COUNTY OF VENTURA PUBLIC WORKS AGENCY WATERSHED PROTECTION DISTRICT ZONE 2 "J" STREET DRAIN IMPROVEMENT ORMOND BEACH LAGOON TO DOWNSTREAM OF HUENEME ROAD IN THE CITY OF OXNARD

SAVE DATE: 5/21/13 DOKTORN K:\PC\PROJECTS\82322 J STREET DRAIN IMPROVEMENT\FINAL DESIGN\DESIGN DRAWINGS\100%ADDENDA\ADDENDUM NO. 1\JSD-01-GP.DWG

"J" STREET DRAIN IMPROVEMENT
ORMOND BEACH LAGOON TO
DOWNSTREAM OF HUENEME ROAD
GENERAL PLAN

SHEET 17
OF 31
DRAWING NO.
Y-2-3721

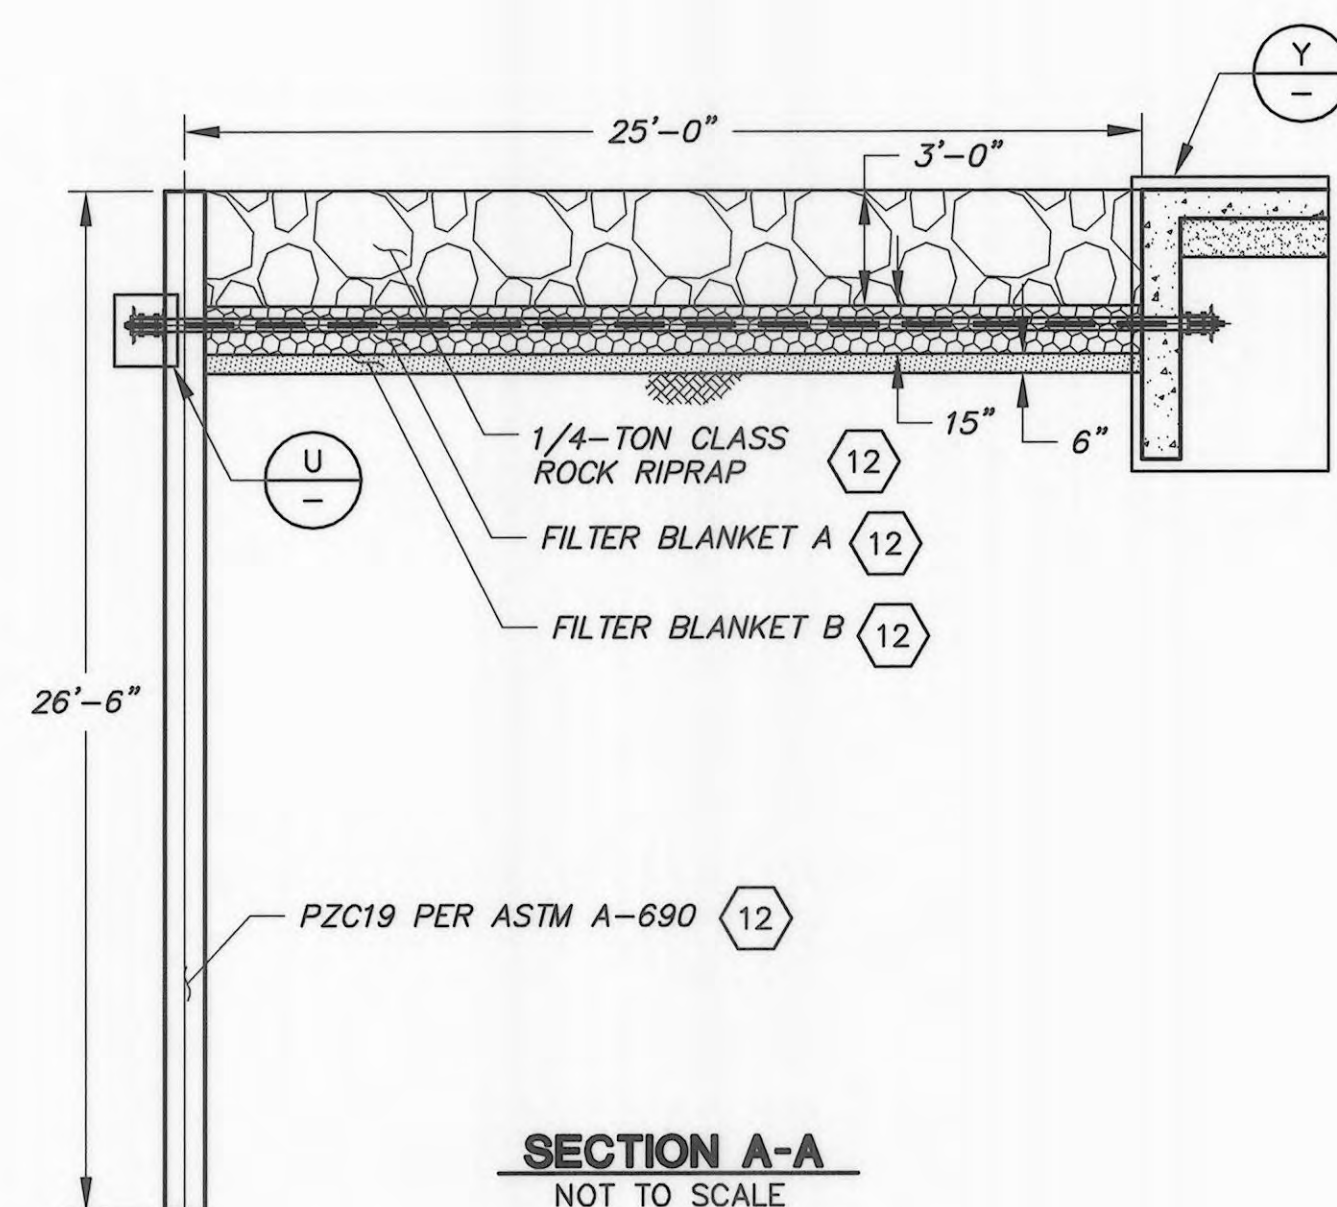
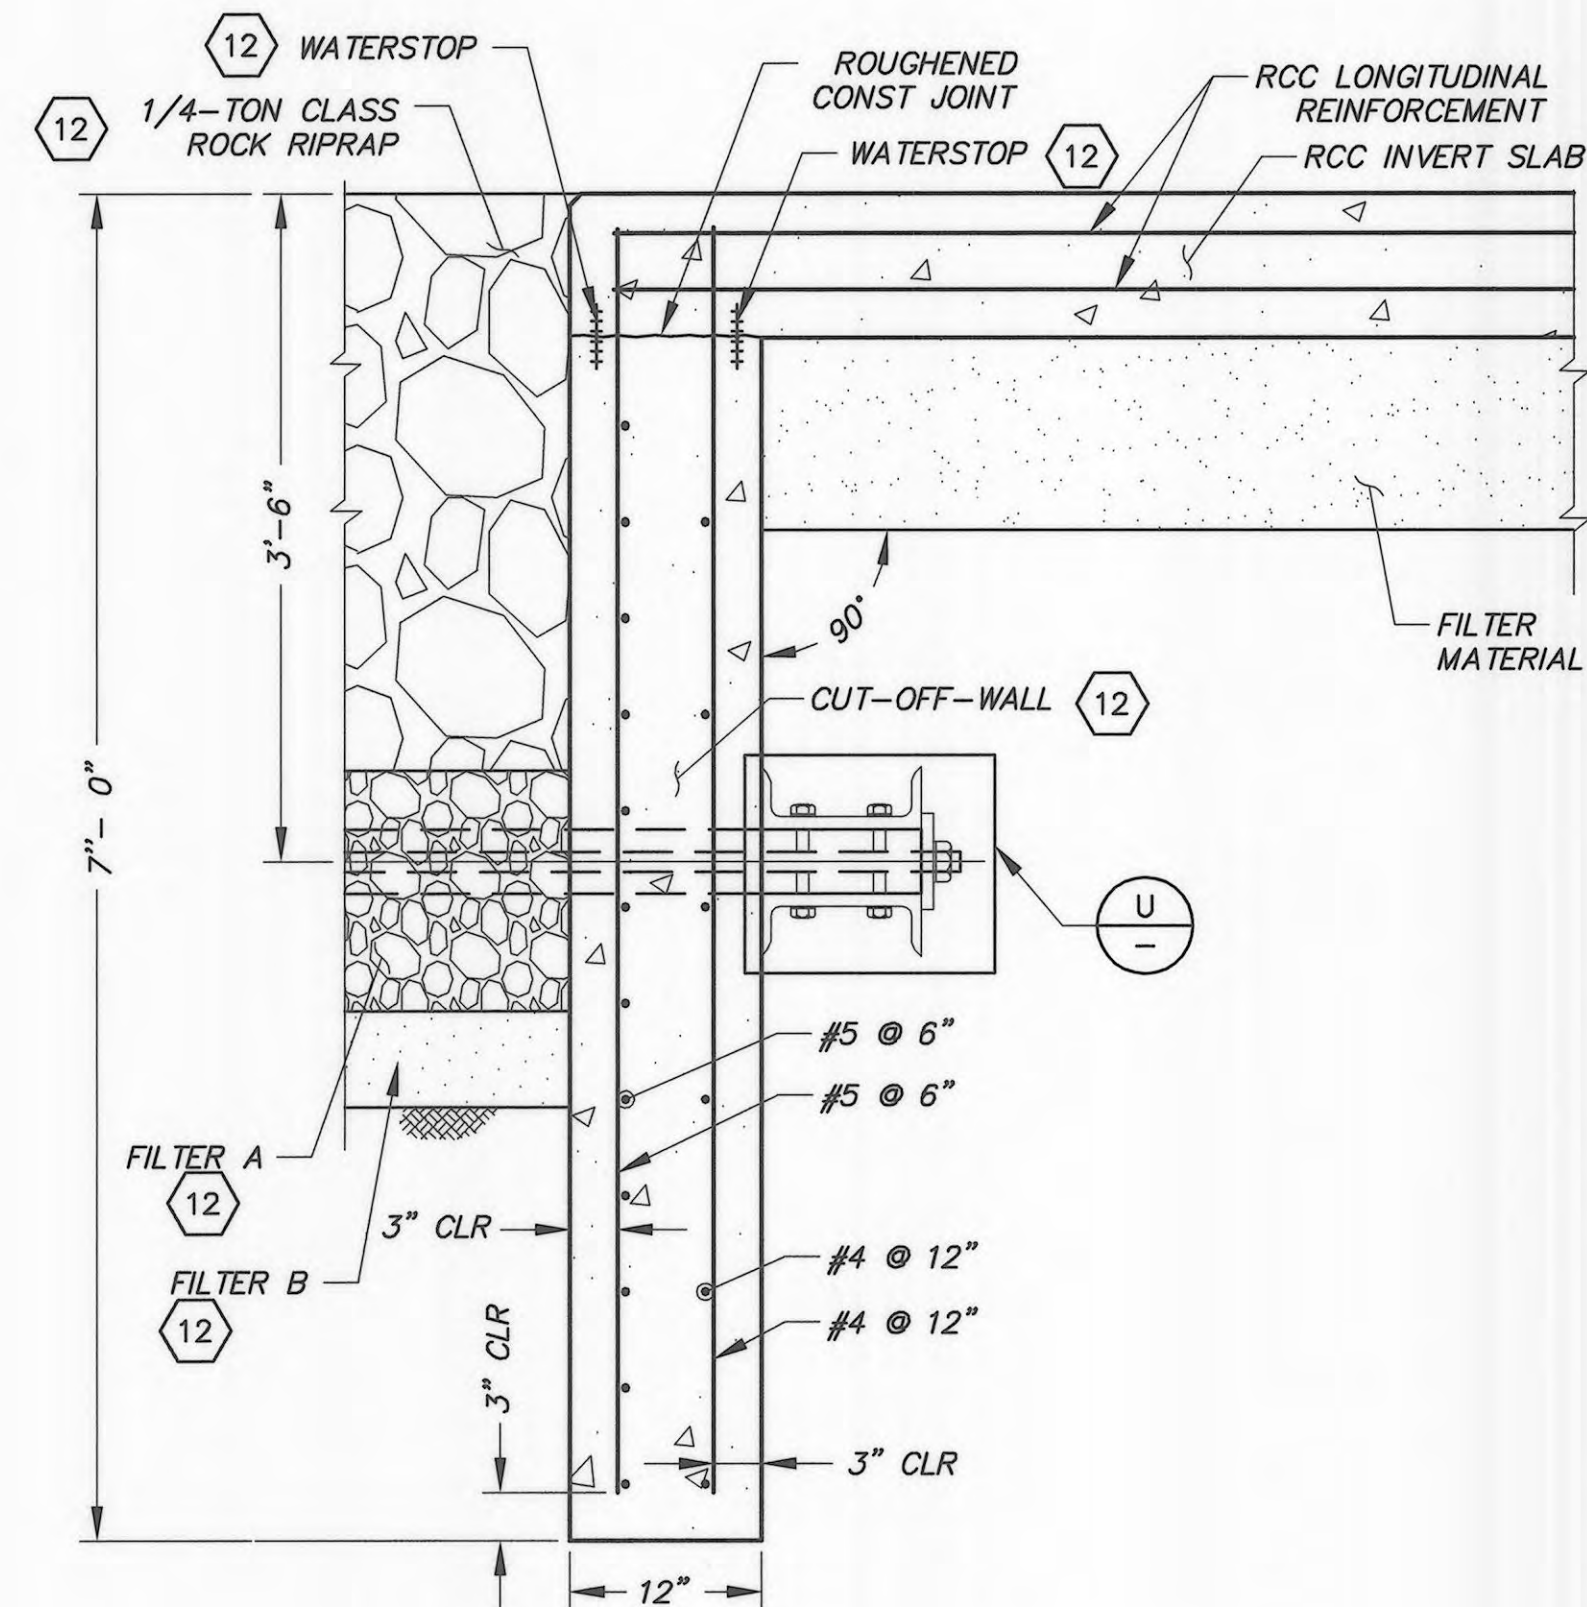
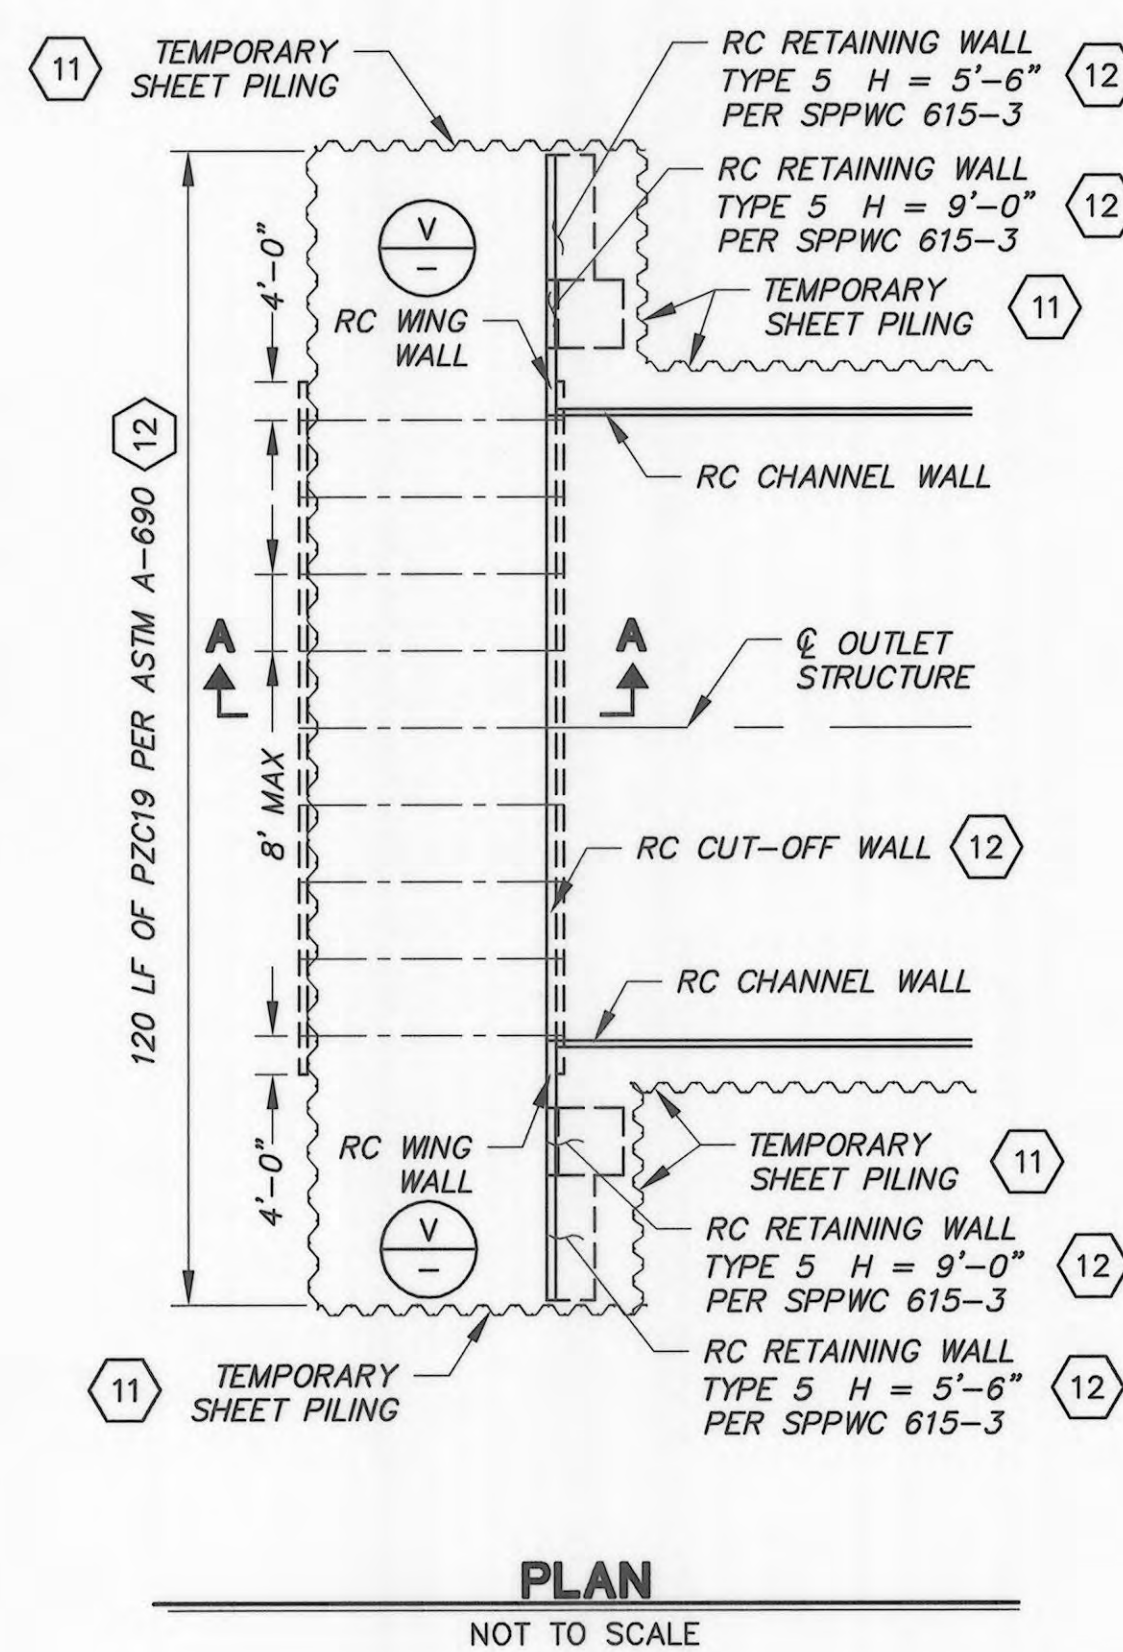
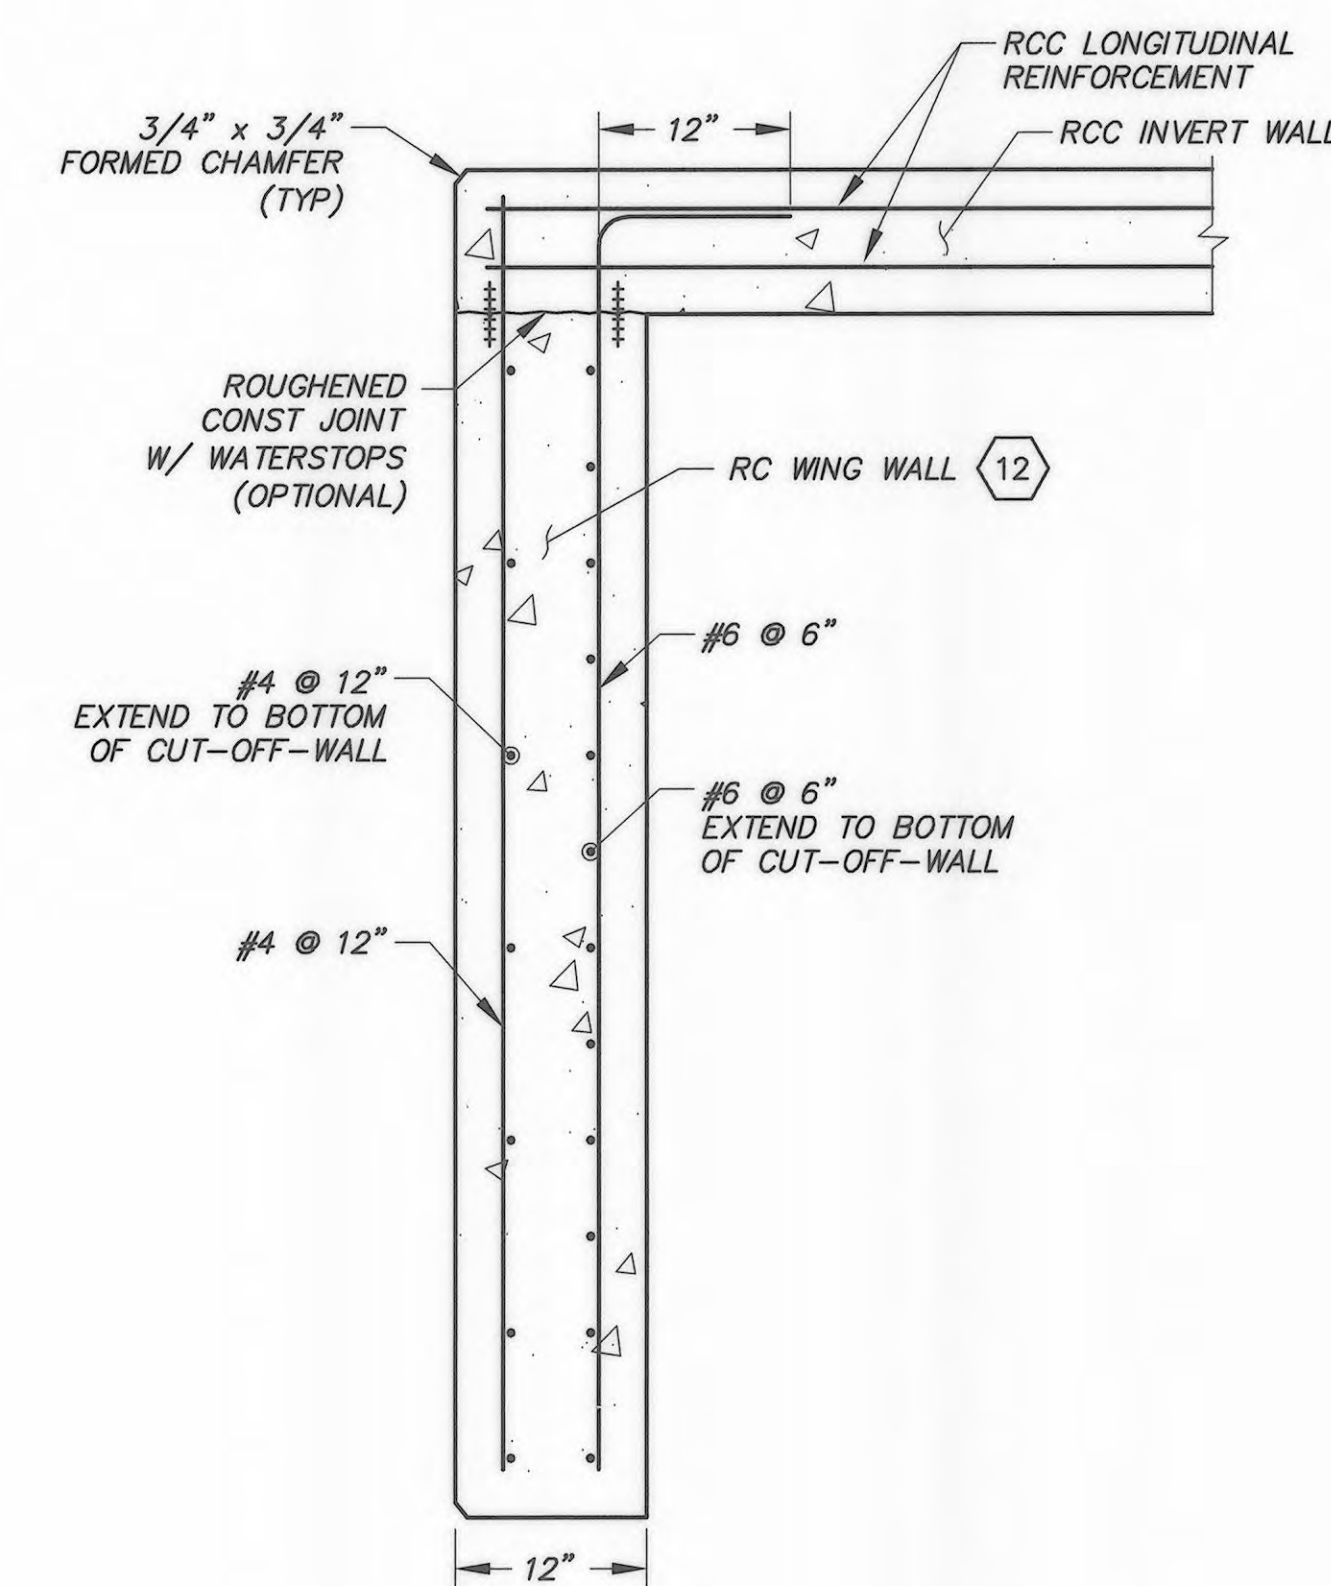
REVISION	DESCRIPTION	APP.	DATE
A	REVISED OUTLET STRUCTURE
